DAVID STARR JORDAN
HIGH SCHOOL
STRUCTURAL STRENGTHENING
AND MODERNIZATION OF
AUDITORIUM AND BOILER HOUSE
2245 E. 103rd ST., LOS ANGELES, CAL.
STATE OF CALIFORNIA - DEPARTMENT OF GENERAL SERVICES
AS RE-DESIGNED FOR RECONSTRUCTION
25132 APPROVED NOV 20 1964

INDEX OF SHEETS, SCHEDULE AND MOSAIC PANEL DETAILS

DAVID STARR JORDAN
 HIGH SCHOOL
 STRUCTURAL STRENGTHENING
 AND MODERNIZATION OF
 AUDITORIUM AND BOILER HOUSE
 2265 E. 103RD ST., LOS ANGELES, CAL.
 STATE OF CALIFORNIA - DEPARTMENT OF GENERAL SERVICES
 DIVISION OF ARCHITECTURE AND CONSTRUCTION
 AS REVISED APR 13 1965
 25132 APPROVED NOV 20 1964
 APPLICATION NO. 100
 PER S. Morgan

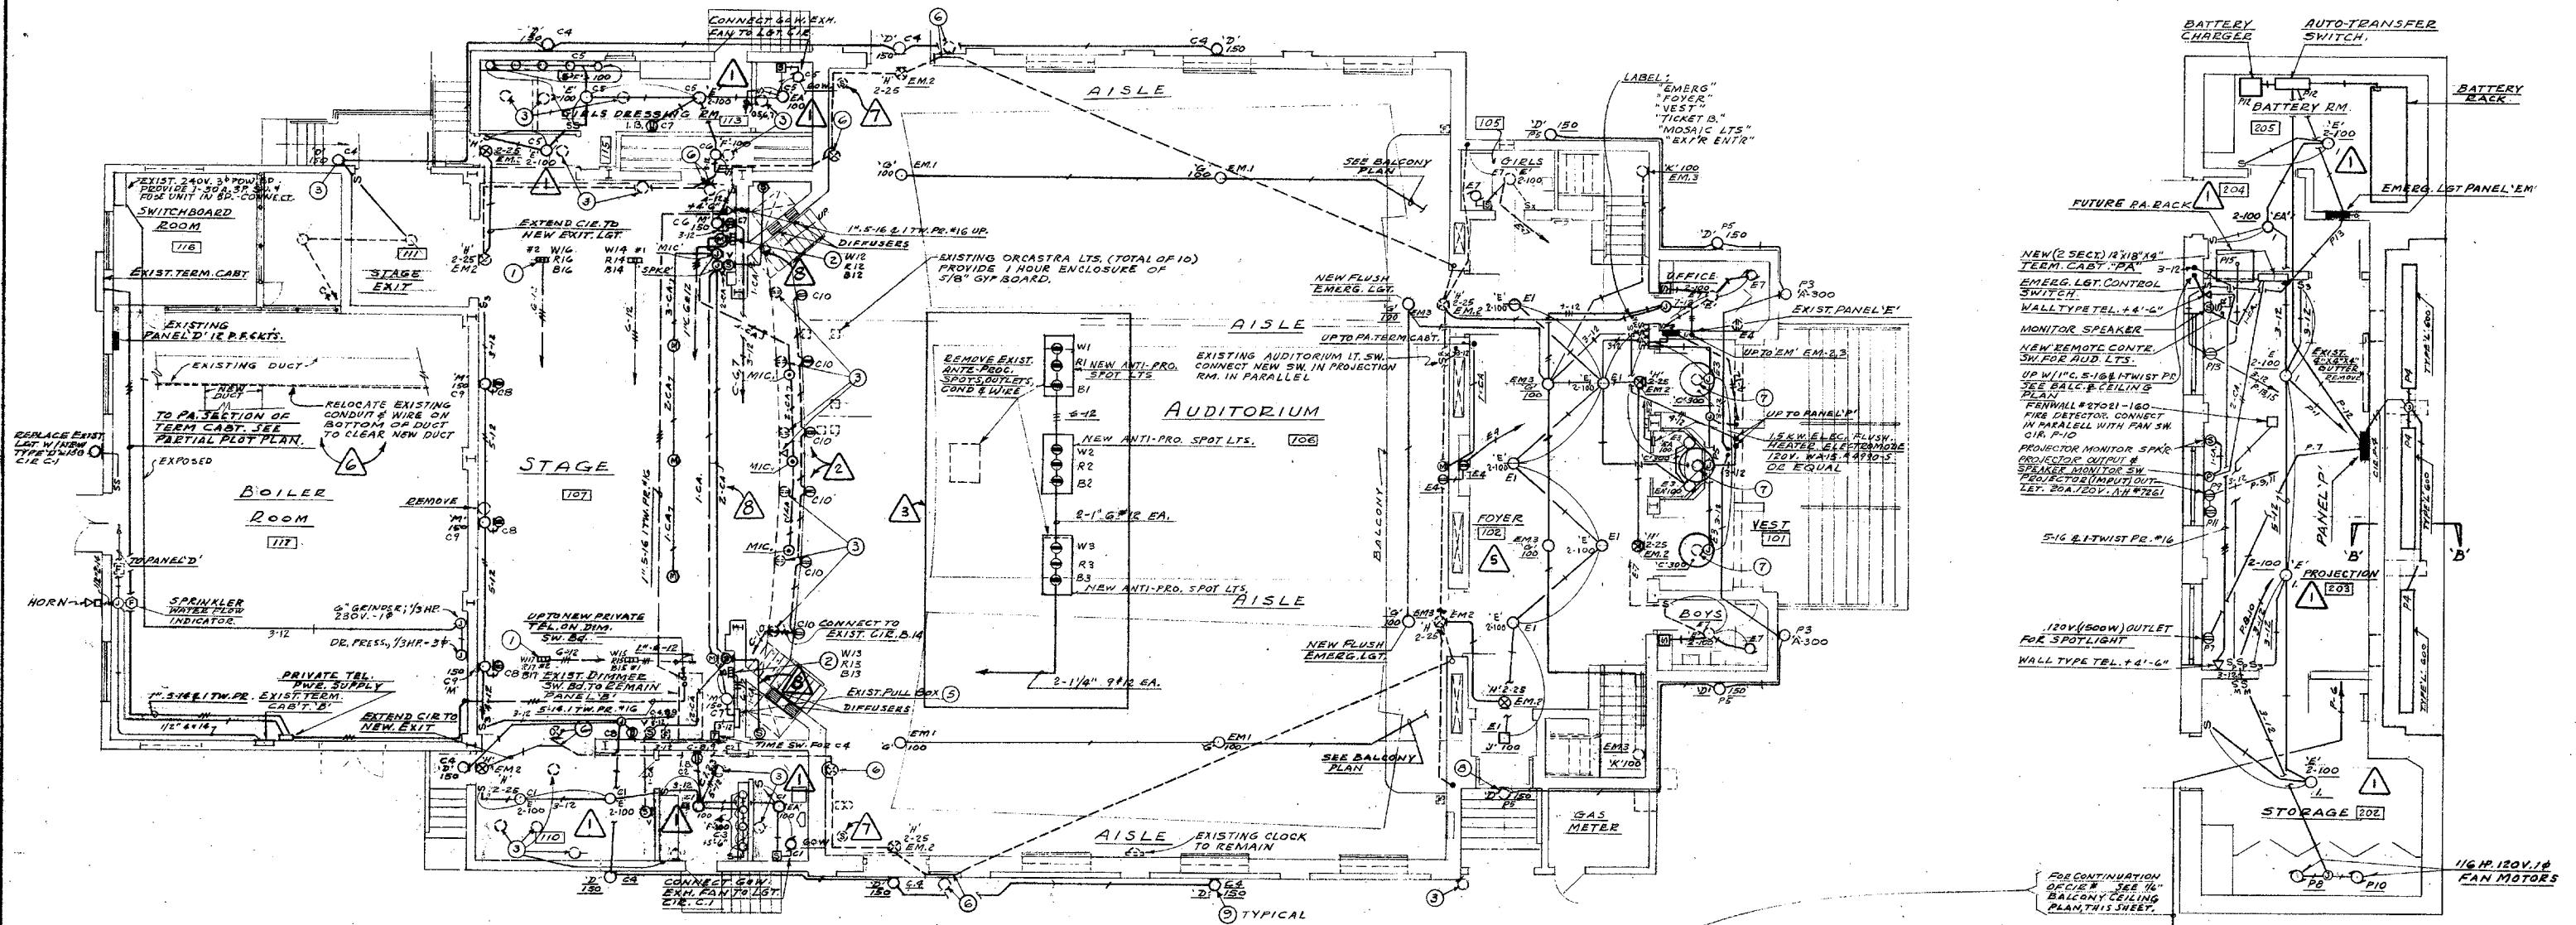
CEILING OMITTED. PROVIDE TYPE 'B' FIXTURES WHERE TYPE 'E' & 'EA' FIXTURES ARE INDICATED. MM. 48" O. RM. 202, 203, 204, 205 - MM. 48" O. RM. 108, 109, 110, 111, 112, 113, 114, 115.

OMIT NOTES # 1 & 2 SHEET 2.

LIGHTING REVISED FOR FLAT CEILING.

REMOVE EXISTING SPEAKERS AND INSTALL & CONNECT THEM IN THE NEW SPEAKER ENCLOSURES.

PROVIDE NEW SPEAKER CABLES FROM NEW LOCATION OF SPKRS TO NEW 'J' BOX ON STAGE.
